FCC ID: G9H2-1006A
Marstech Report No. 22182D
EXHIBIT C(2)-1

CCT TELECOM LTD.			
DATE: 16 Aug 2002	MODEL: WDCT (4 Layers)		
DRAWN BY: Franky Hui	TITLE: 21006RF.SCH		
CHECKED BY:	Power Amplifier and LNA		
APPROVED BY:			
PCB NO.:		DRAWING NO.:	
DISK NAME:		SHEET: 2 OF 3	REV.: 0

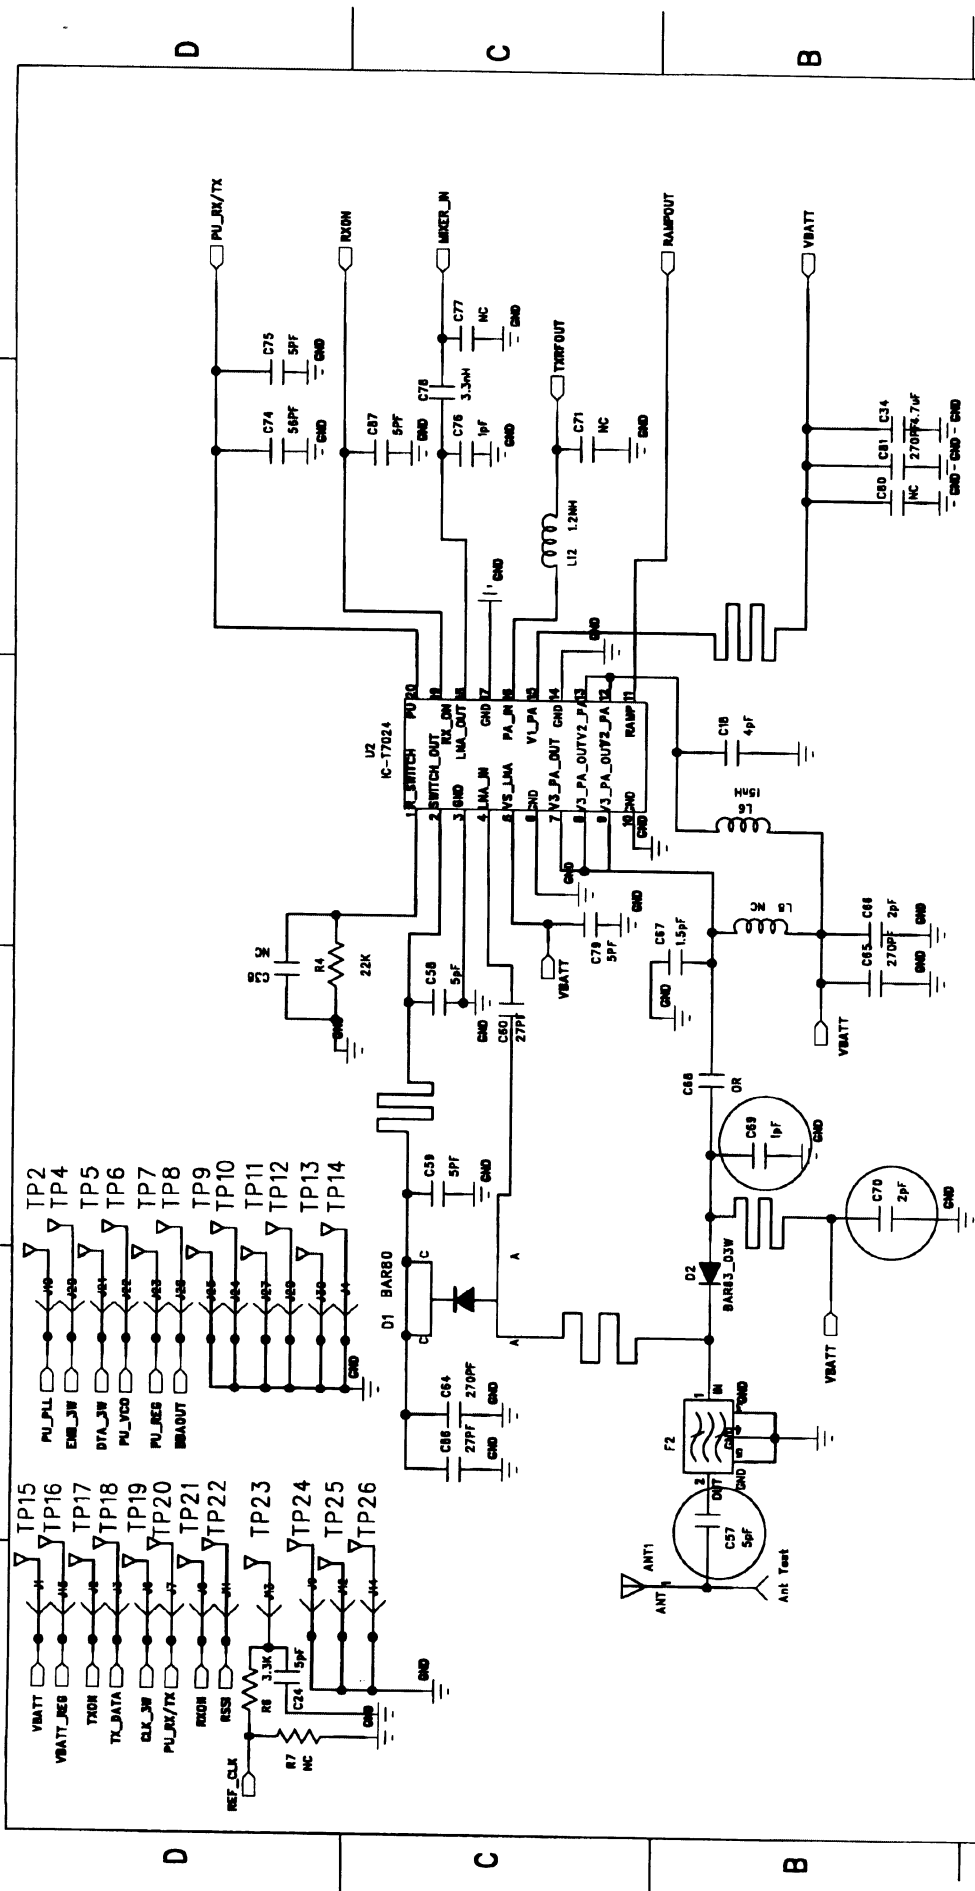
Changes List

Part Desc	Original	Change To	Remark
C57	15pF	5pF	Reduced Harmonics
C70	1pF	2pF	Reduced Harmonics
C69	0.5pF	1pF	Reduced Harmonics
